Access Compliance Report

Public Rights-of-Way

(Curb Ramps)

Intersection ID: 18772	Main Street: JESTER_LN	Cross Street: WHEELER_DR	Location: SW
ADA ID: C3646BAAB087	Ramp Type: PerpDiag	Initial Pass/Fail: Fail	Overall Compliance: No
			Severity Score: 26.25

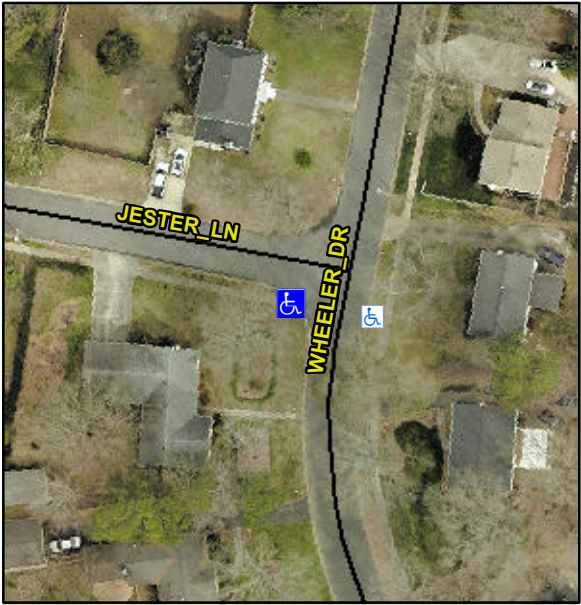
Codes/Mitigation Info/Possible Solution			Field Measurements/Component Compliance		
	Possible Solutions:		Compliance	Description	Data
	Remove & Replace Curb Ramp With Two New Directional Ramps or Equivalent.		No	Ramp Length (in)	50.0
			Yes	Ramp Width (in)	48.0
			N/A	Flare Type LT	N/A
			N/A	Flare Slope LT (%)	N/A
			N/A	Flare Traversable LT?	N/A
			N/A	Landing Length (in)	N/A
			N/A	Landing Width (in)	N/A
			N/A	Landing Slope (%)	N/A
			N/A	Landing X Slope (%)	N/A
			N/A	Landing Curb? (Y/N)	N/A
			N/A	Shared Landing?	N/A
			N/A	Gutter Ponding?	N/A
			N/A	Gutter Lip Ht (in)	N/A
			No	Painted X Walk1?	N/A
				X Walk 1 Direction	To E
			N/A	X Walk 1 Width (in)	N/A
				X Walk 1 Slope (%)	2.7
				X Walk 1 X Slope (%)	6.2
			N/A	Ramp inside XWalk1?	N/A
<p>Surveyor Notes:</p> <p>N/A</p> <p>PROW/ADA:</p> <p>Not Found, R304.2.2, R304.5.3</p>			N/A	Flare Type RT	N/A
			N/A	Flare Slope RT (%)	N/A
			N/A	Flare Traversable RT?	N/A

N/A	DWS Provided?	N/A
			N/A	DWS Contrast?	N/A
			N/A	DWS Length (in)	N/A
			N/A	DWS Full Width?	N/A
			N/A	DWS Offset (in)	N/A
			N/A	Gutter Slope (%)	N/A
			N/A	Gutter X Slope (%)	N/A
			No	Painted X Walk2?	No
				X Walk 2 Direction	To N
			N/A	X Walk 2 Width (in)	N/A
				X Walk 2 Slope (%)	5.3
				X Walk 2 X Slope (%)	2.4
			N/A	Ramp inside XWalk2?	N/A
			N/A	Clear Space?	N/A
			N/A	Clear Space to XWalk (in)	N/A
			N/A	Storm Grate/Utility Hazard?	N/A
				Storm Grate/Utility Type	
<p>Total Cost:</p> <p>\$ 3200.00</p>			N/A		N/A
			Yes	Surface Condition? (G/P)	Good
